**PRELIMINARY PLAN OF SUBDIVISION**  
4-20040

**WEST HYATTSVILLE**  
2700 HAMILTON STREET, HYATTSVILLE, MD 20782

Re: West Hyattsville  
PPS-20040  
Soltesz, No.: 07060600

In response to the comments generated at the SDRC meeting July 23, 2021, we offer the following responses:

# PROPOSED 100-YEAR FLOODPLAIN DELINEATION PLAN

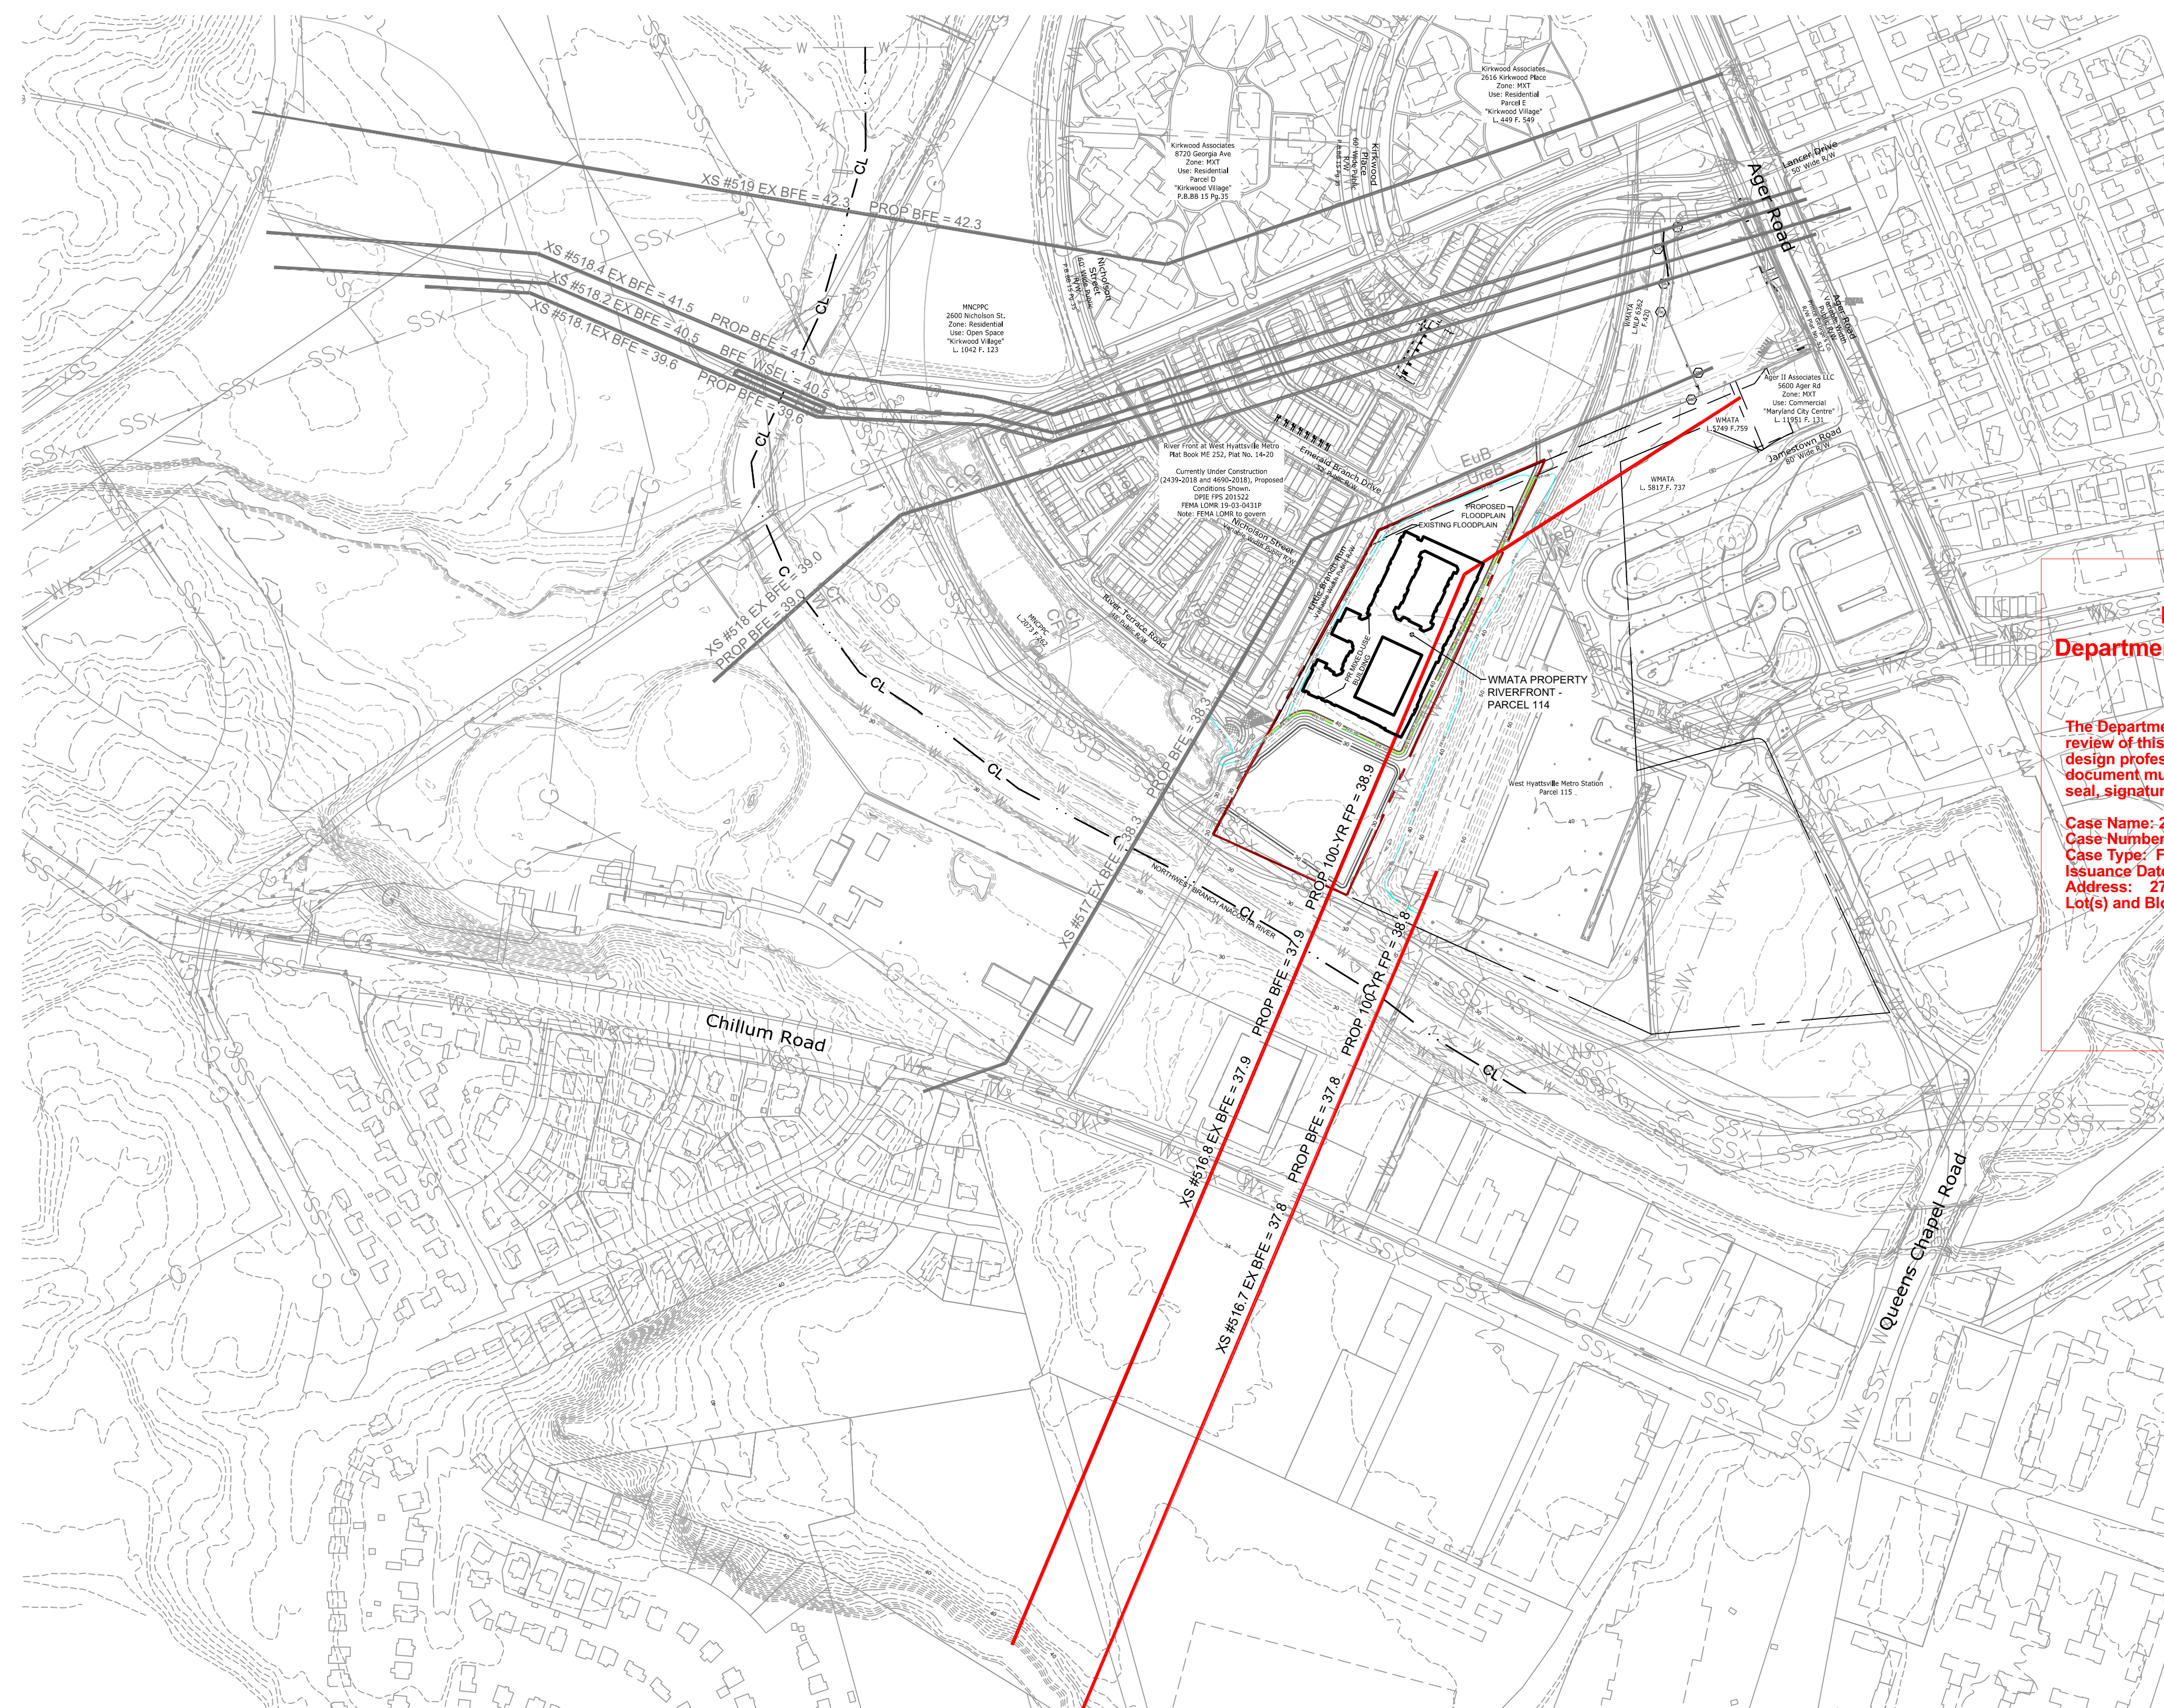
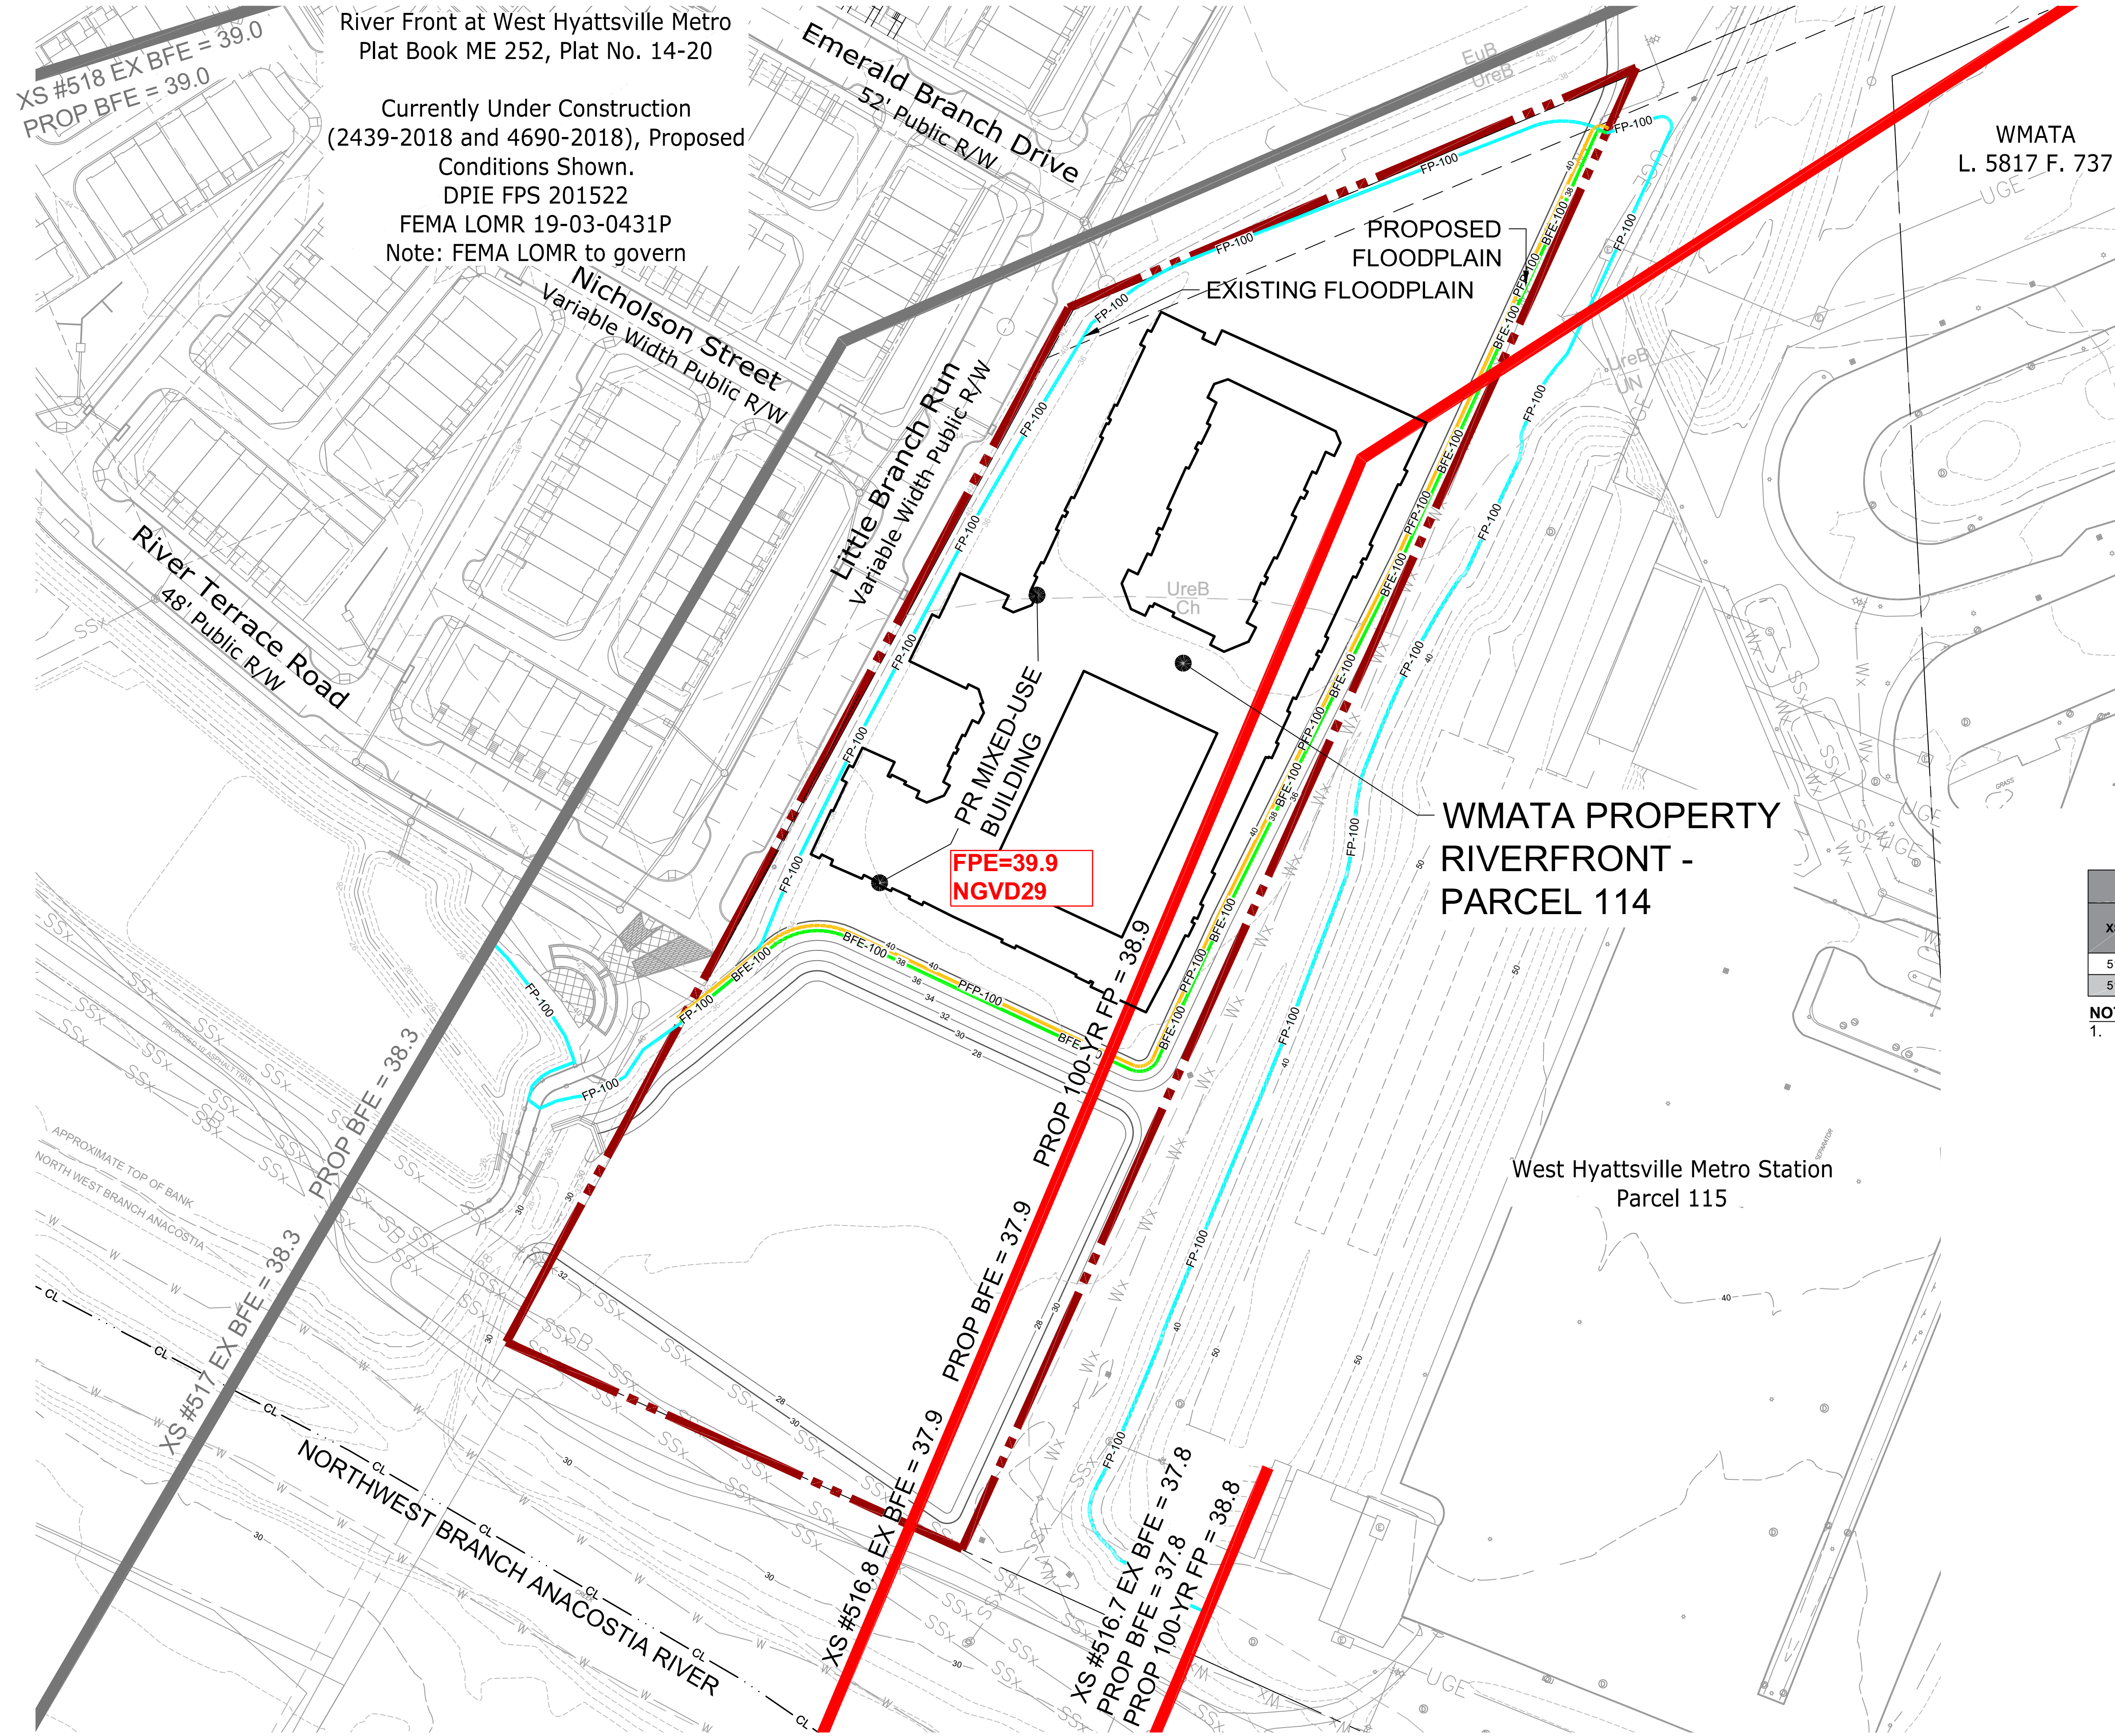
Comment 1: Proposed Parcel 2 is completely within the existing 100-year floodplain. Need to see proposed conditions floodplain delineation as approved by DPIE, to ensure that the parcel is buildable for the use intended.

**Response: The approved floodplain and waiver have been included.**
